Structural Compliance Certificate (Construction)

Description of Inspection: Steel Frame, Steel Trusses and Structural Steel Inspection for Proposed Building 3

Our Reference: Your Reference:	BR200435-SC-Building3-rev02				Level 7 22 Cordelia S South Brisbar	
19/09/2023					T 07 3844 590	00
					www.acor.cor	n.au
Richard Crooke Level 3, 4 Broa	s Construction P/L				ENGINEERS	
Artarmon, NSW					MANAGERS	
,					INFRASTRUC PLANNERS	CTURE
Attention: Ms Ar	ngela Wang				DEVELOPME CONSULTAN	
Dear Angela,						
STRUCTURA	ctural Certification – Build	uilig 3				
Site Details:						
Project Name.	Kingscliff Public School					
Street no. / Stree	•					
Suburb:	Kingscliff	State:	NSW	Postcod	e: 2487	
Description of	Work:		New double st	orey classroo	ms (Building 3)	
Consent:						
SSD No. SSD-8378620-MOD-1		Consent auth	nority:	N/A		
			Dated:		15 June 2023

SITE INSPECTION REPORT

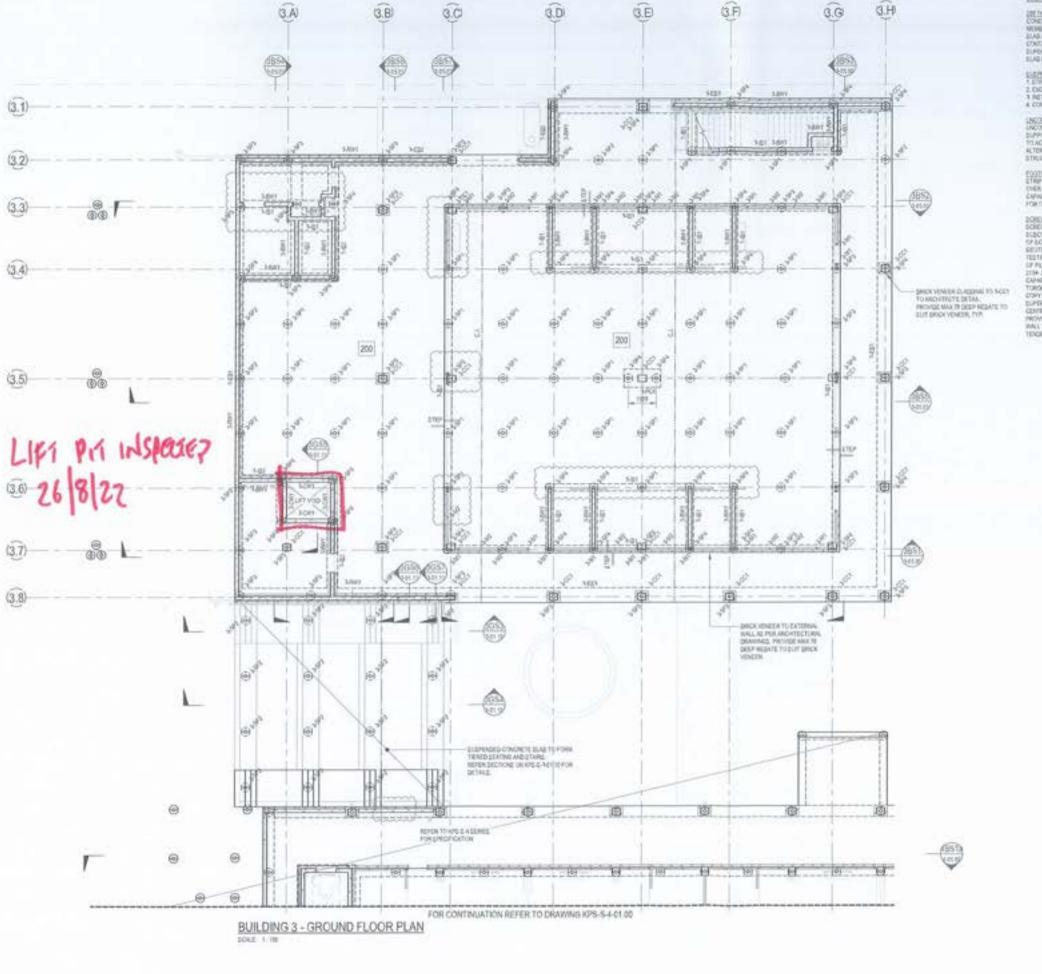
3.	ENSURE PIT-WALLS- TO SLAB Z BARR
2.	ARE SET AT THE CORRECT HT.
3-	
4.	REMOVE ALL DEBRIS From BASE.
5.	
6.	ADD REMAINS Z'BARS
8	then on to Four.
9.	7.74 - 7.14
10.	
11.

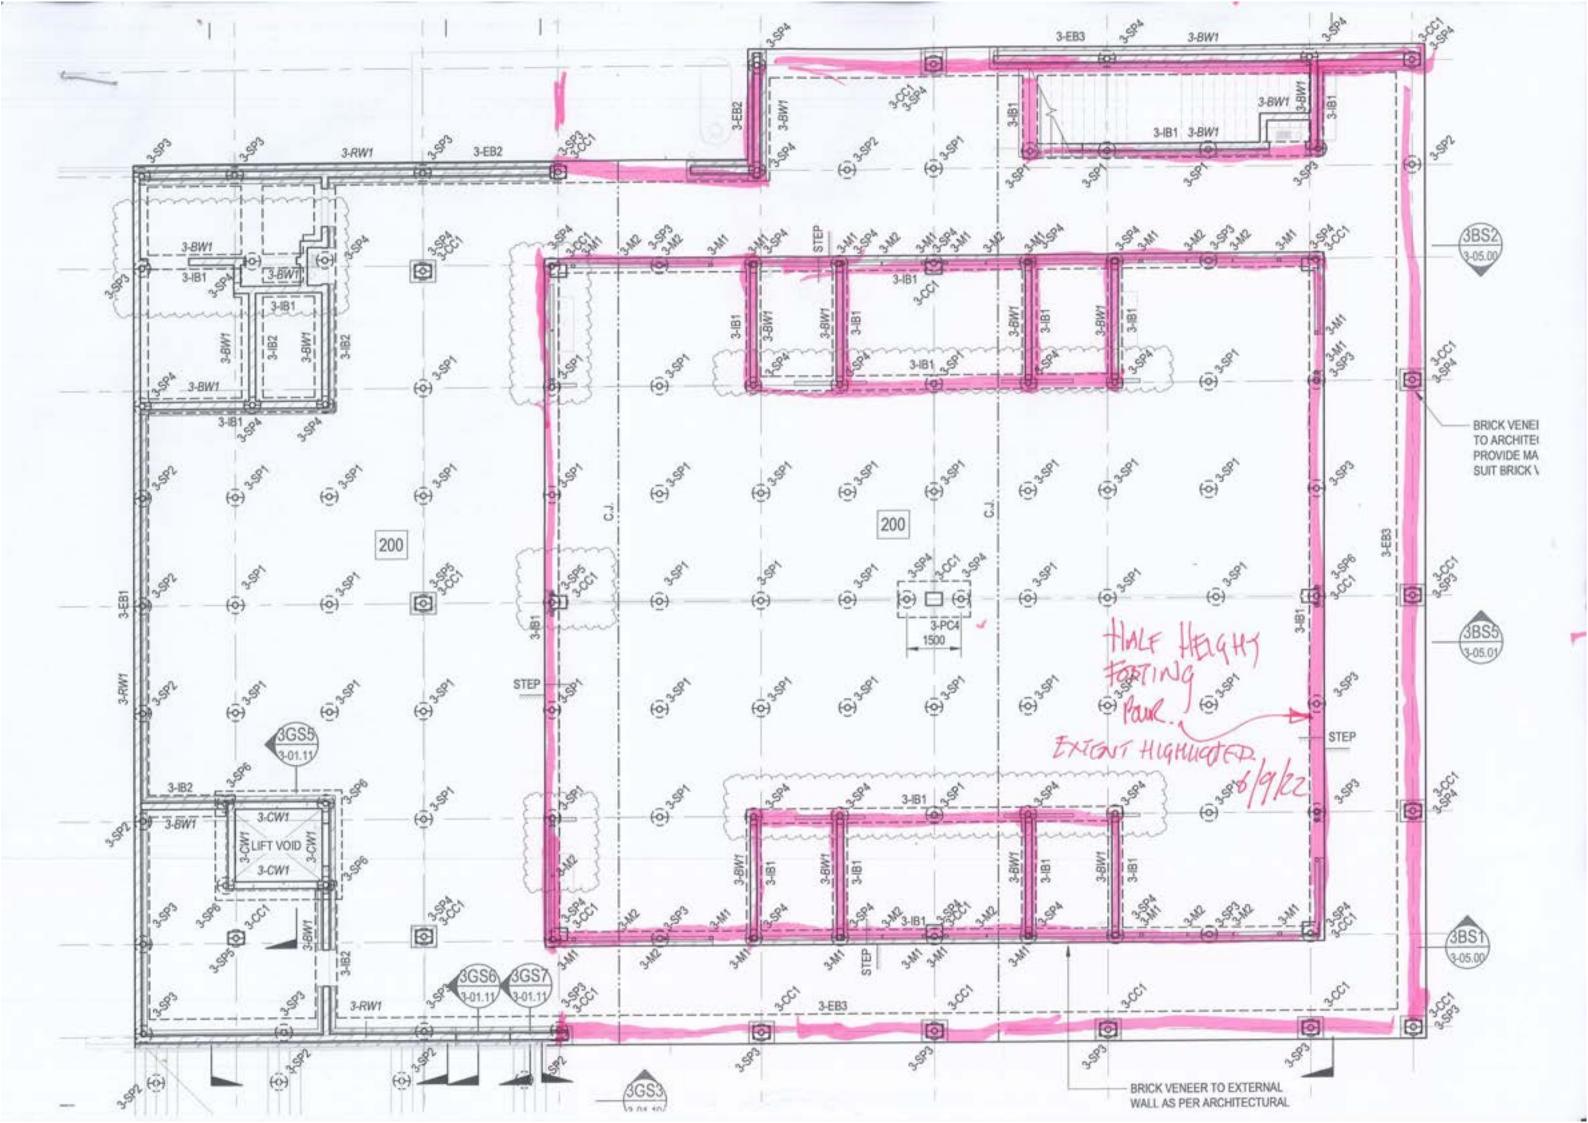
1.	Reinforcement to footings all satisfactory and ready for partial pour height. Refer attached mark up for extent
2.	Ensure all remaining pile shear bars are in position.
3.	Remove all debris from bottom of footing
4.	
5.	When above complete ok to pour
6.	
7-	
8.	
9.	
10.	
11.

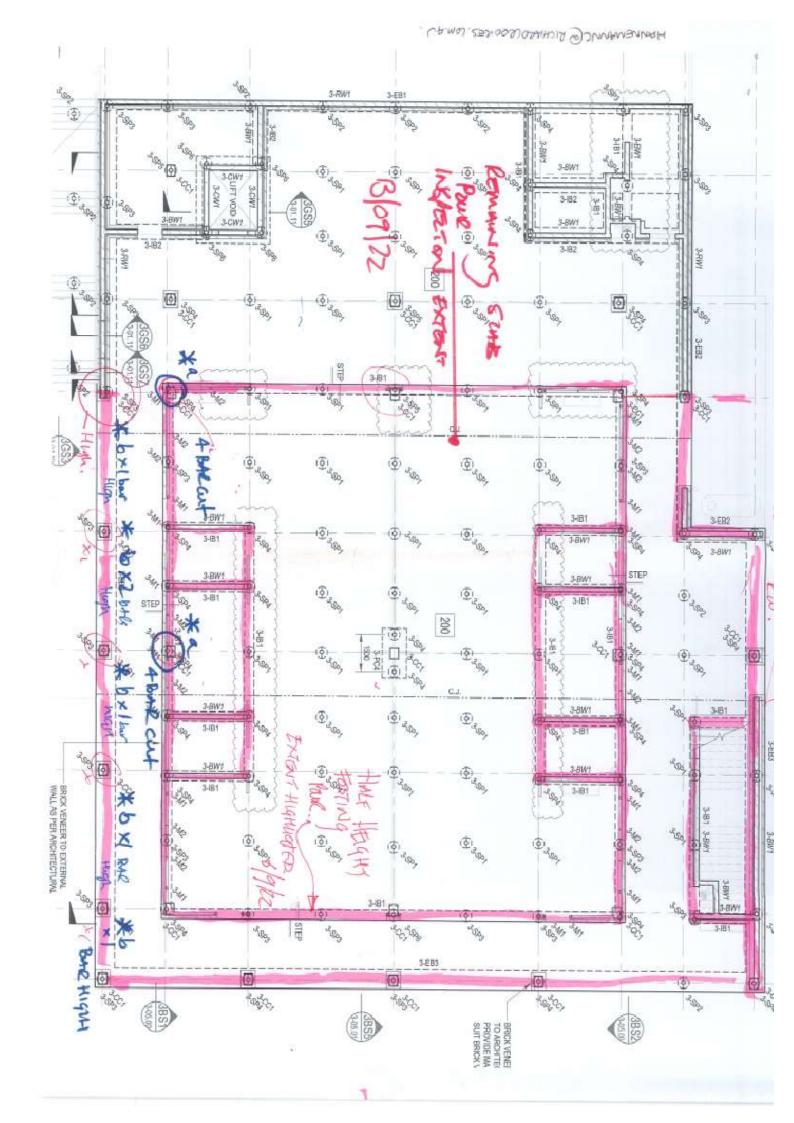
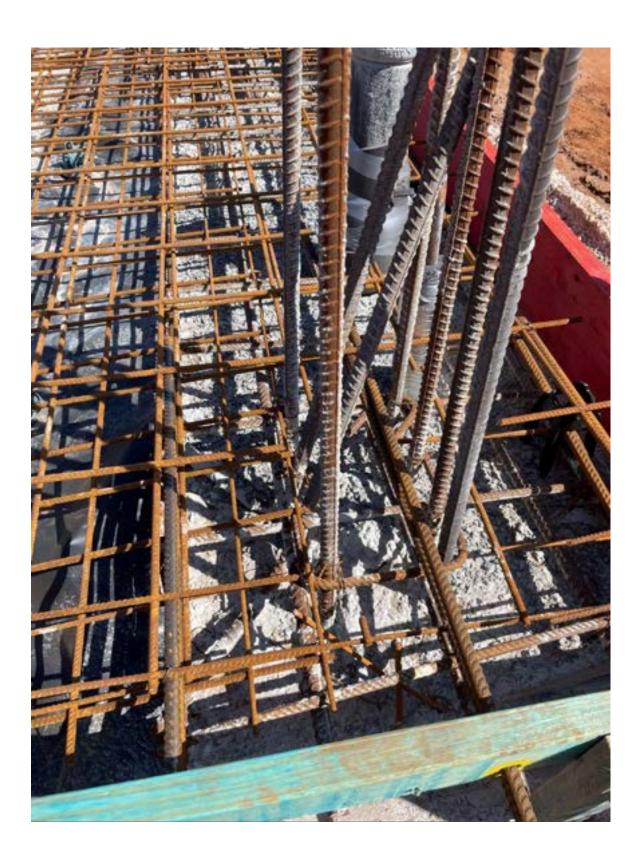
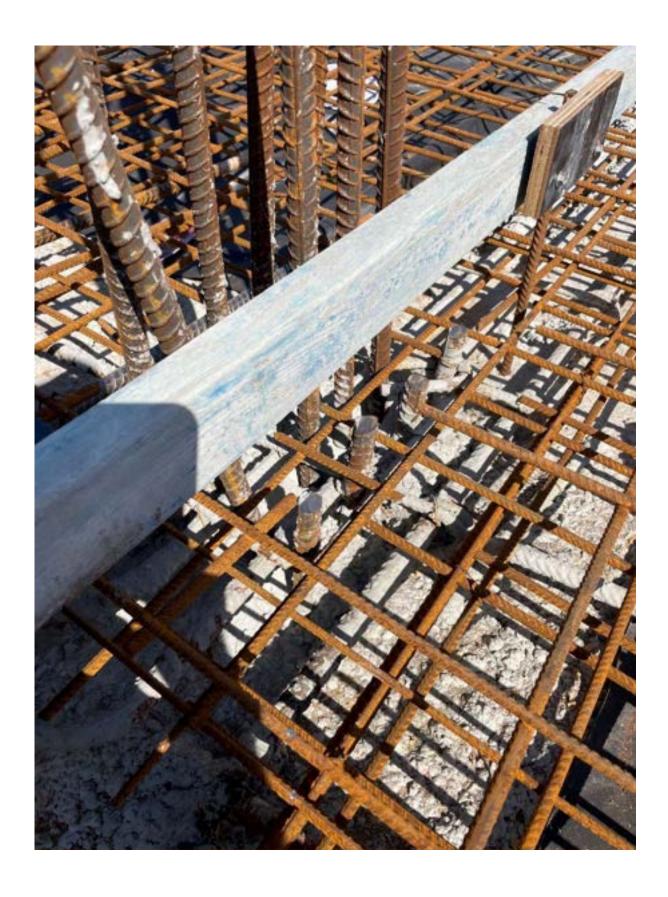
2.	BUARS CUT OFF. (REFER PIC + MARKEY
3.	* 6) CHOWN STARTER BARE TIED TO
g:	TOP OF FOOTING RED.
5-	CRETION PIC + MEARLY UP FOR COUNTION
5,	1 NUMBER OF BARS)
3, *	ENSURE GERRET COVER OF MEST 10
	SIDE FORM WORK.
10.	· REENTRANT BARS WHERE NEEDED
1

Drawing Title
STRUCTURAL
BUILDING 3 - GROUND FLOOR PLAN

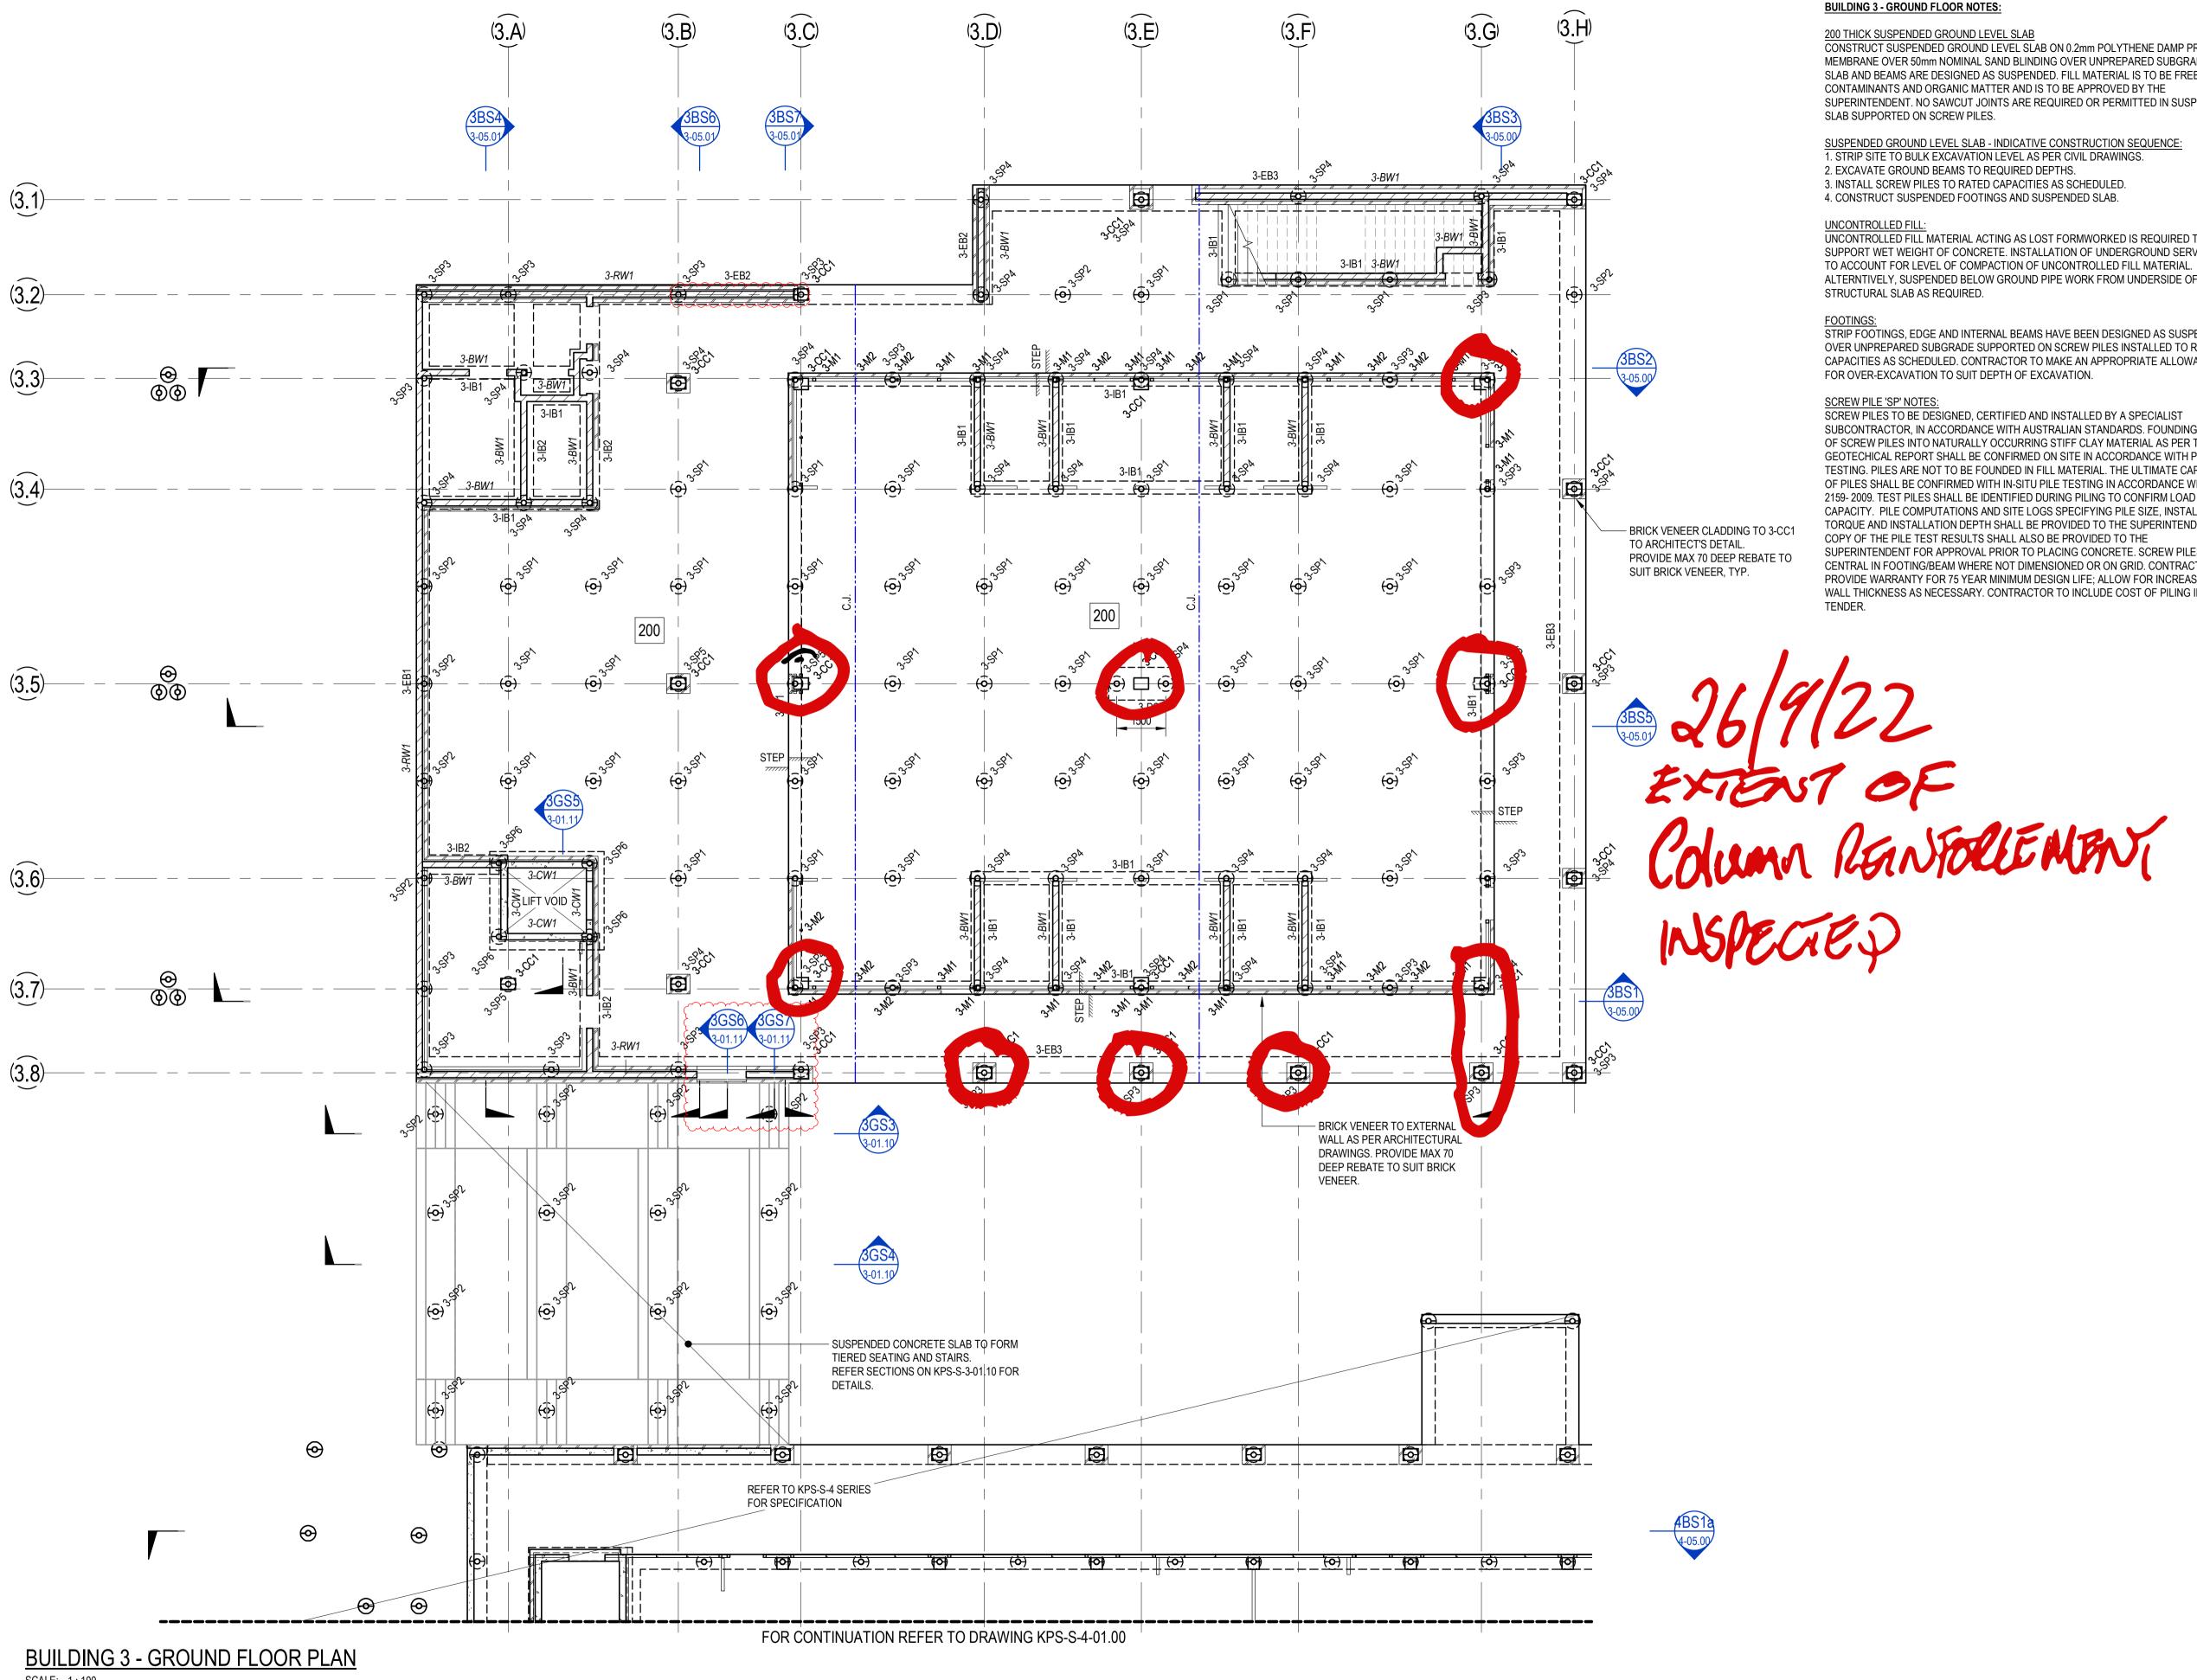
1. * ExTENT LEFER ATACKED MANDER	-u/
2.	
3. * ALL SUTTESFACTORY.	
4.	
5. * ENSURE COLLET COVER	
5. * ENSURE COLLET COVER. 6. FROM FORMWORK.	
7.	
8.	
9.	
10.	
11.
